**Bid Bulletin #02**

PROJECT: Ashland Community Resource Center  
Ashland, NE

## ADDENDUM NO. 2

Addendum #02  
Supplemental Drawing: SDL-002  
Revision of Sheet: L2.02  
Date: February 8, 2013

# 8 BRICK UNIT PAVEMENT

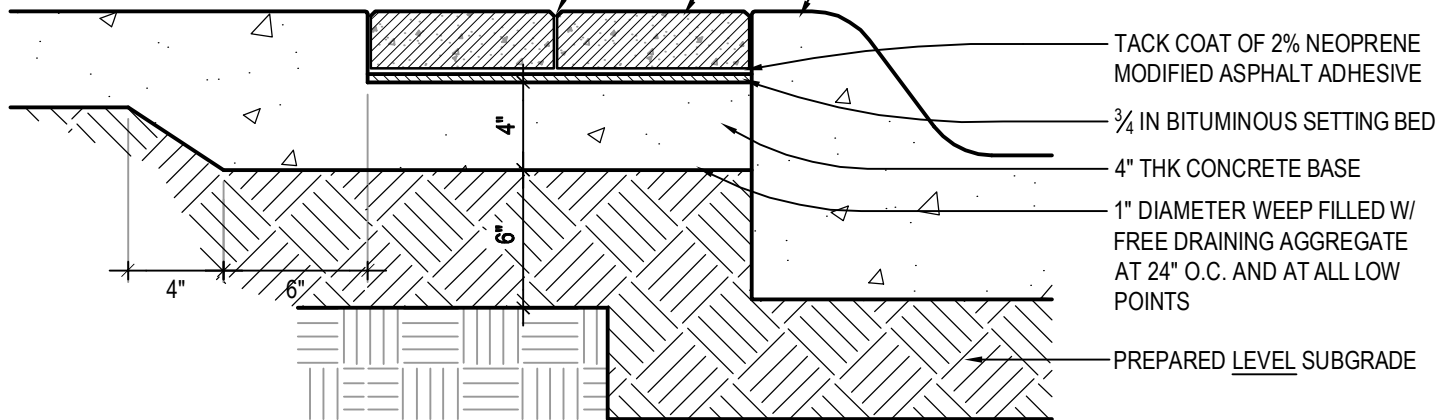
**Item 2-3: Refer to Sheet L2.02 – Site Details**

Detail 8 has been revised. See SDL-002 for additional details.

**AL-101**

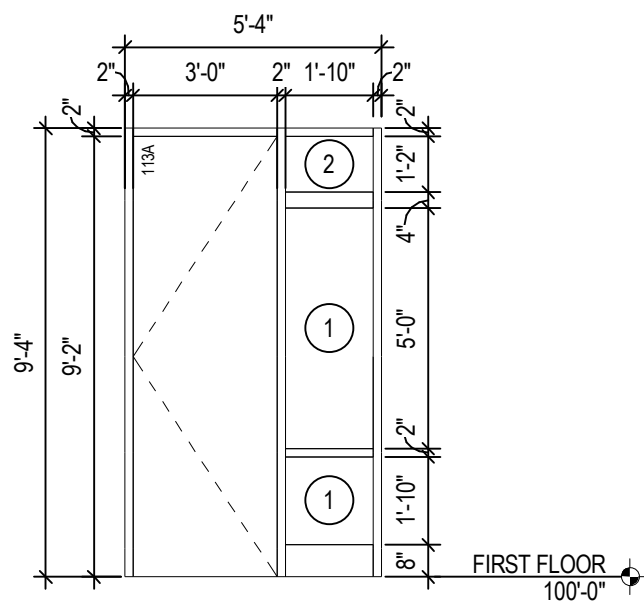
**Item 2-12: Refer to Sheet A6.09 – Door Schedule, Door Types & Aluminum Frame Types**

Refer to Frames: AL-101, AL-102, AL-112, AL-113, AL-114, AL-115; revised as shown in SDA-001.
